### DSC Information Notice #186

#### **Topic: Revisions to the Public Works Standards for Pavement Patches**

The Public Works Specifications and Standards are in the process of being transformed into the Public Works Design Standards. As a part of this process, the pavement patch standards were revised to match past changes in the Virginia Department of Transportation pavement designations. Attached to this notice are the following revised pavement patching standards for immediate use:

C-3A

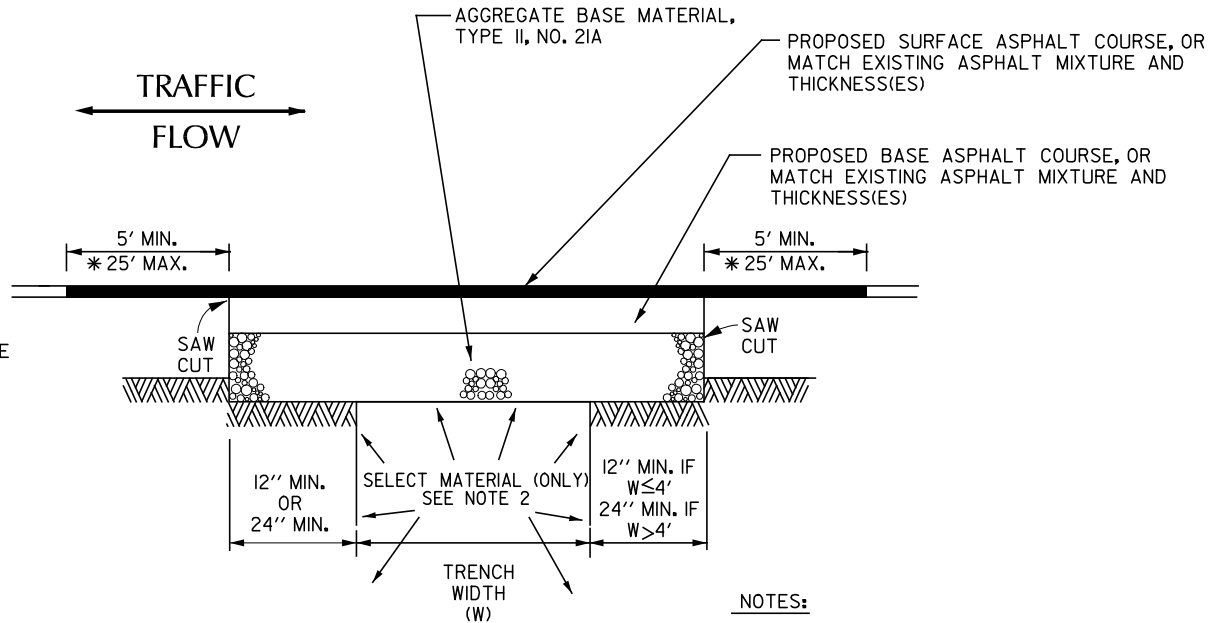
- C-3a – Flexible Pavement Patch for Local & Collector Streets
- C-3b – Flexible Pavement Patch for Major & Minor Arterials
- C-4 – Rigid Pavement Patching

ROADWAY PATCH FOR ASPHALT (ONLY) STREETS WITH THE CLASSIFICATION OF LOCAL OR COLLECTOR SHALL BE THE GREATER OF:

- MATCH THE EXISTING PAVEMENT, OR
- 1 1/2" SM-9.5A SURFACE ASPHALT CONCRETE, OVER 3" BM-25.0A BASE MIX ASPHALT CONCRETE, OVER 6" AGGREGATE BASE MATERIAL, TYPE I NO. 21A, OVER COMPACTED SUBGRADE IF SUBGRADE IS A MINIMUM CBR OF 15. OTHERWISE SELECT MATERIAL WITH CBR ≥ 15 TO BE USED AS BACKFILL. IF CONCRETE IS UNDER ASPHALT, THEN CONCRETE MUST BE USED AND MATCH EXISTING PAVEMENT. SEE NOTE #1.
